S. Taylor # 29

1.4.1.5 Alternative 4.7

U.S. Highway Camino Safety Project

Phase 1 – Option 2: Bridge east of Ponderado Rd with R/A
 Funded with SHOPP and HSIP - Construction start Fall 2019

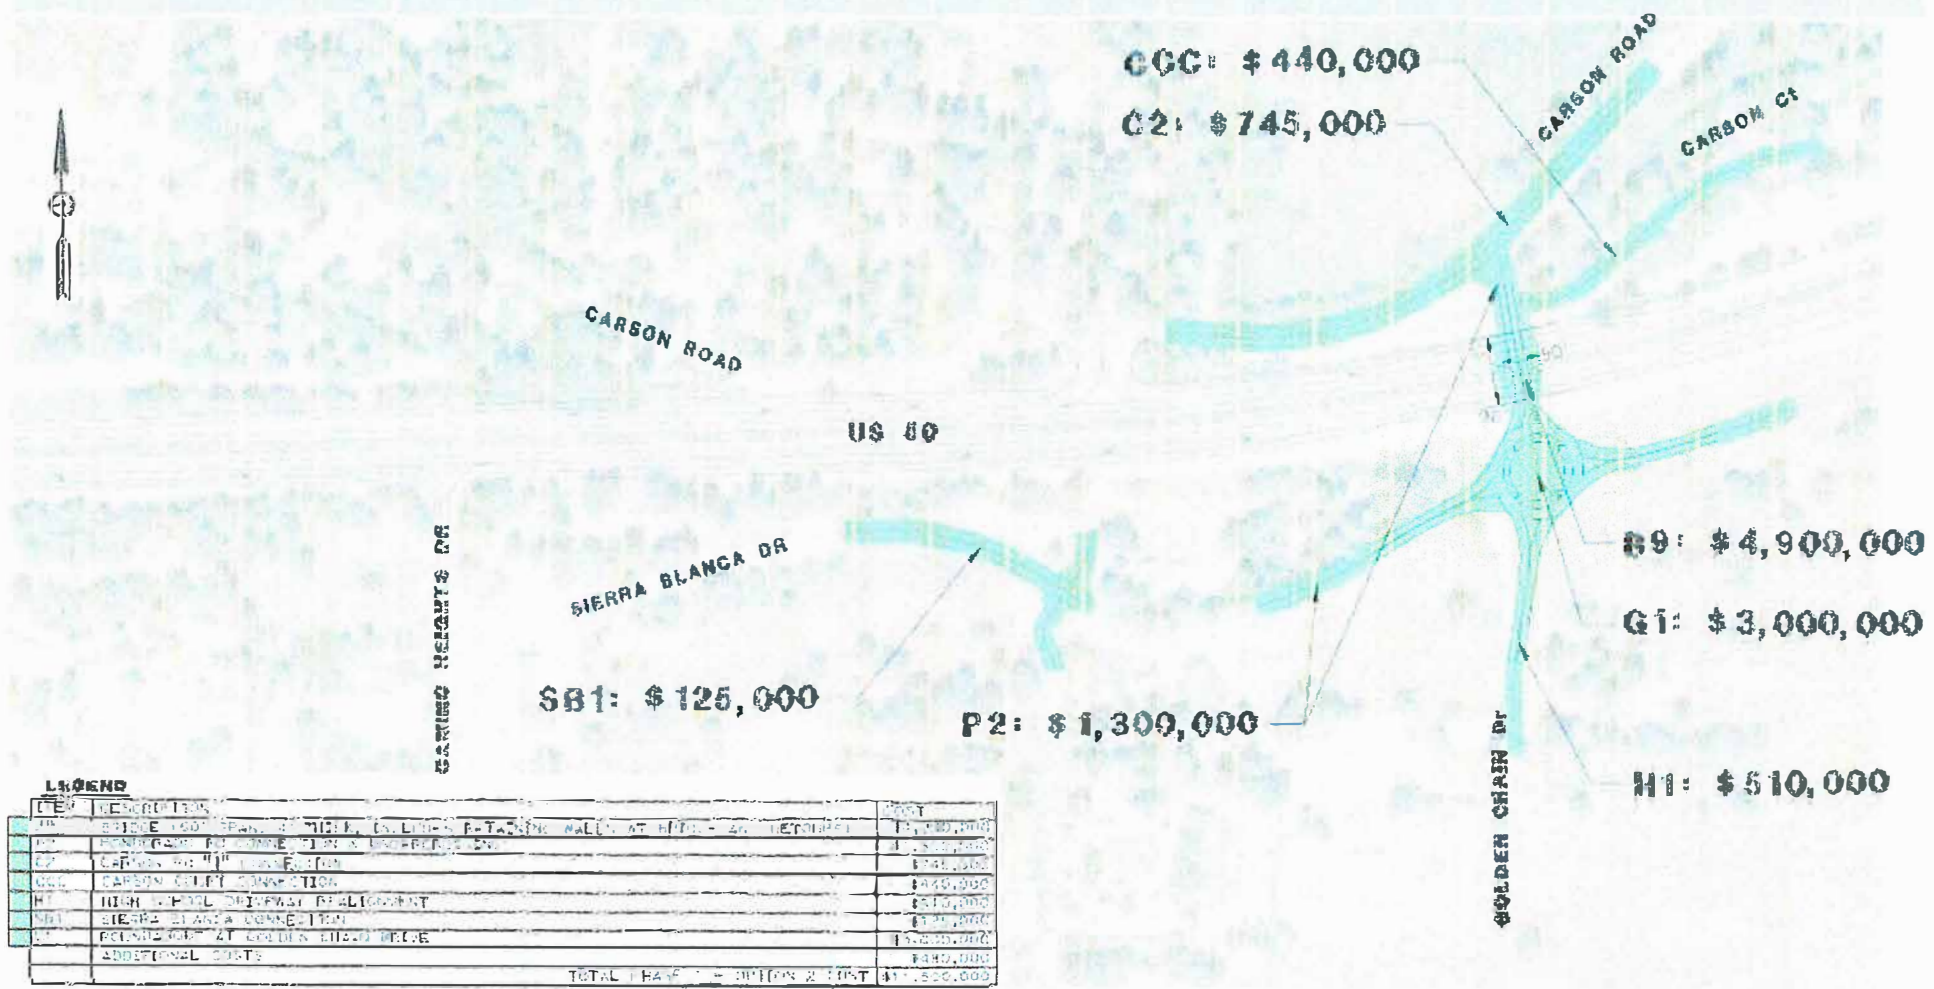
For Alternative 4.7, there may be a need, due to Apple Hill seasonal traffic conditions, to implement temporary traffic control and close this new UC and to route the traffic 1.8 miles east of the Cedar Grove interchange, which is currently being used for high volume weekends.
